Nomination Form
Anadromous Waters Catalog

Anadromous Waters Catalog Number of Waterway: 111-40-10280

Name of Waterway: Sheep Creek

Route Correction for Sheep Creek (111-40-10280)

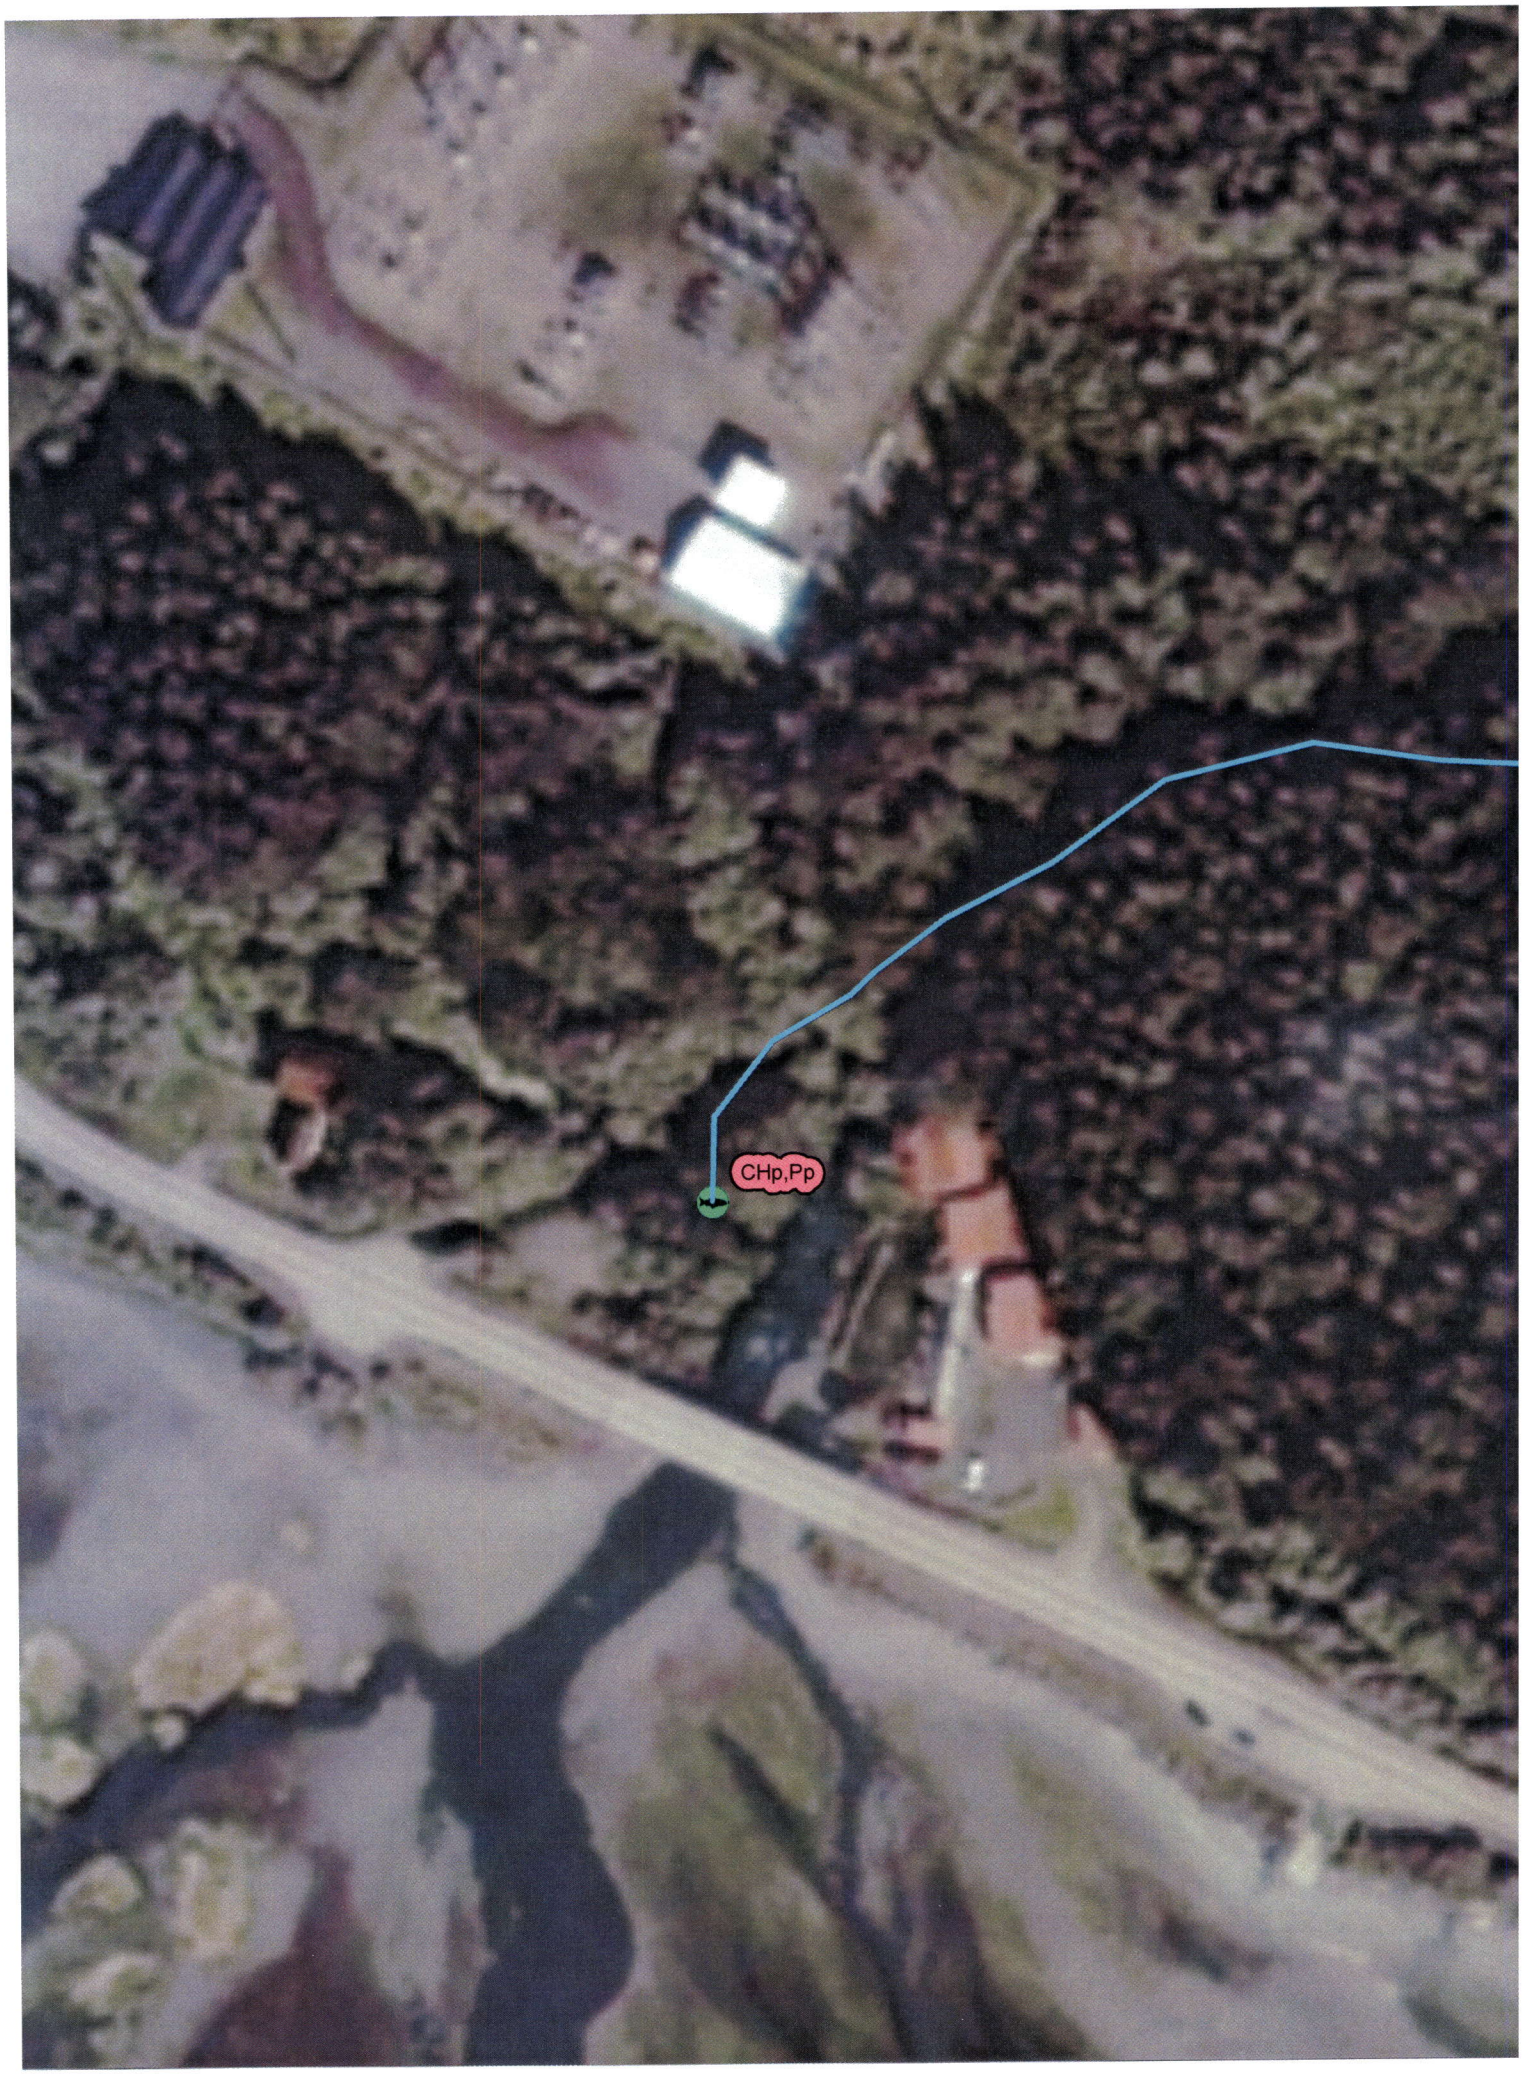
The existing cataloged route for Sheep Creek in Juneau B-2 Southeastern Region was tracked for stream path accuracy on June 9, 2010. The actual upper extent of the stream terminates at a falls with a height of 124.5 feet with a gradient of approximately 30%. The following coordinates mark the upper and lower anadromous extents of Sheep Creek for the existing cataloged species.

CHp,Pp

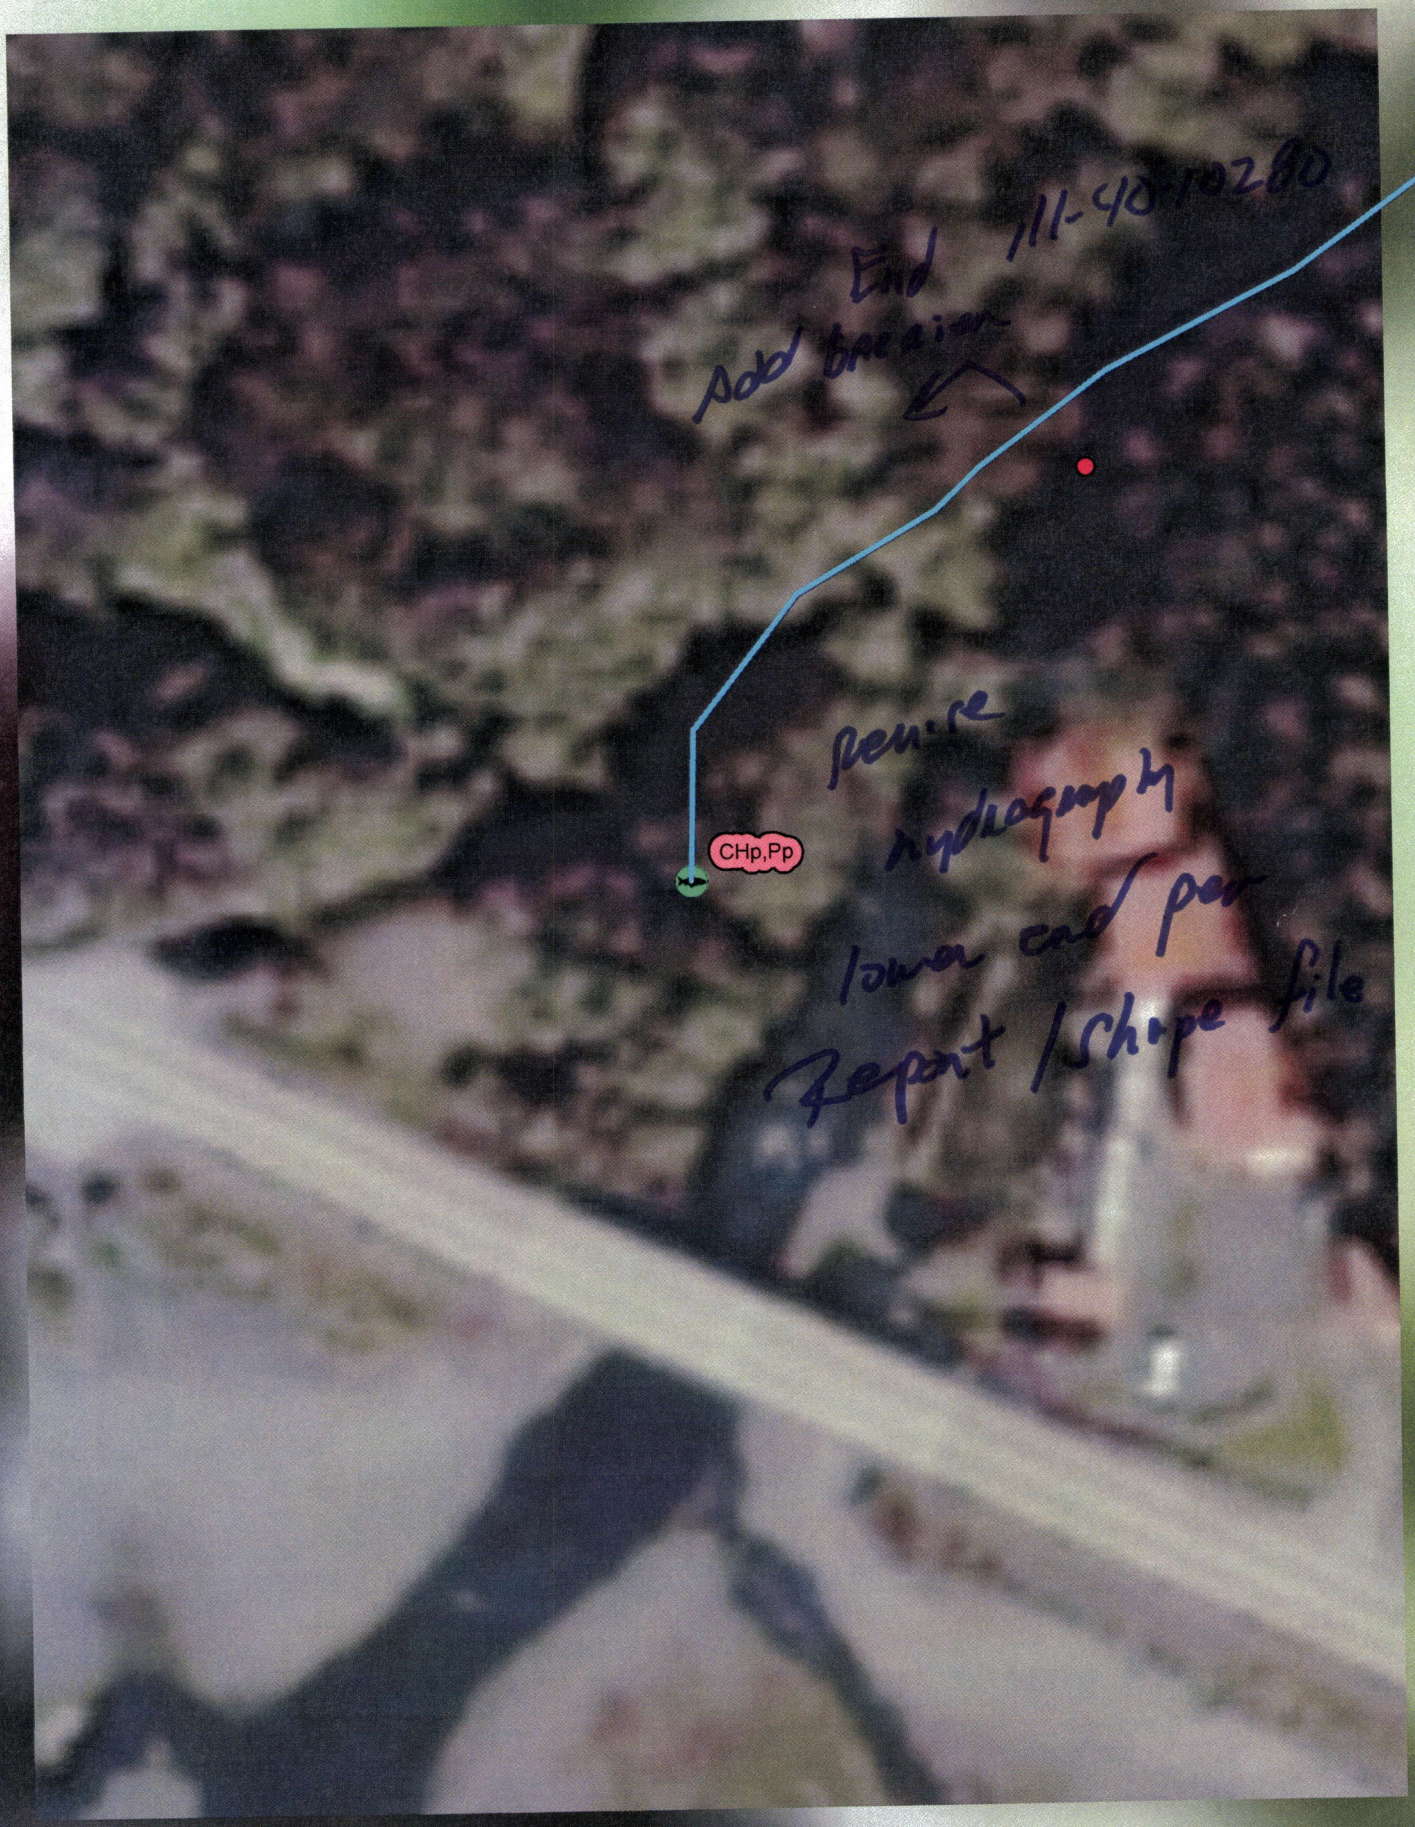
End 711-40-10280
Add breaker
CHp,Pp
Revise
hydrography
lower end per
Report / shape file
